To: T10 Technical Committee
From: Timothy Hoglund (LSI Logic)
Subject: SAS Pathway Recovery modification

Revisions to current Pathway Recovery text**4.8.4.4.3 Pathway Recovery**

Figure 1: Pathway Recovery Priority

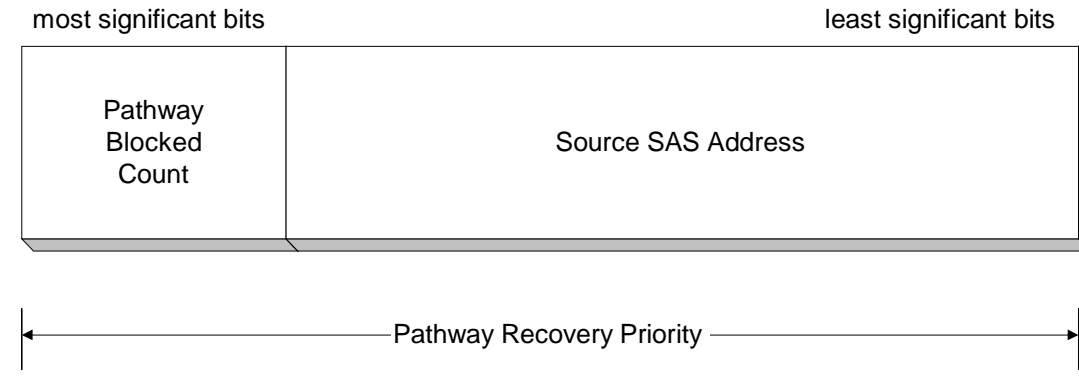
Pathway recovery provides a means to abort connection requests in order to prevent deadlock-
using Pathway Recovery Priority comparisons. Pathway Recovery Priority is defined as the concatenation of PATHWAY BLOCKED COUNT and the SOURCE SAS ADDRESS fields within the OPEN address frame of a blocked connection request. Figure 1 illustrates the components of Pathway Recovery Priority.

The Expander Function shall instruct the arbitrating link to reject the connection request by transmitting OPEN_REJECT(PATHWAY_BLOCKED) when the PPT timer expires and ~~one of the following conditions are met: the Pathway Recovery Priority of the arbitrating link (link requesting the connection) is less than the Pathway Recovery Priority of all links within the destination port with an arbitration status of WAITING_ON_PARTIAL.~~

~~the Pathway Blocked Count value of the arbitrating link (link requesting the connection) is less than the Pathway Blocked Count value of all links within the destination port with an arbitration status of WAITING_ON_PARTIAL; or~~

- ~~b)a) the Pathway Blocked Count value of the arbitrating link is equal to the Pathway Blocked Count value of all links within the destination port with an arbitration status of WAITING_ON_PARTIAL and the source SAS address of the arbitrating link is less than the source SAS address of all links within the destination port with an arbitration status of WAITING_ON_PARTIAL.~~
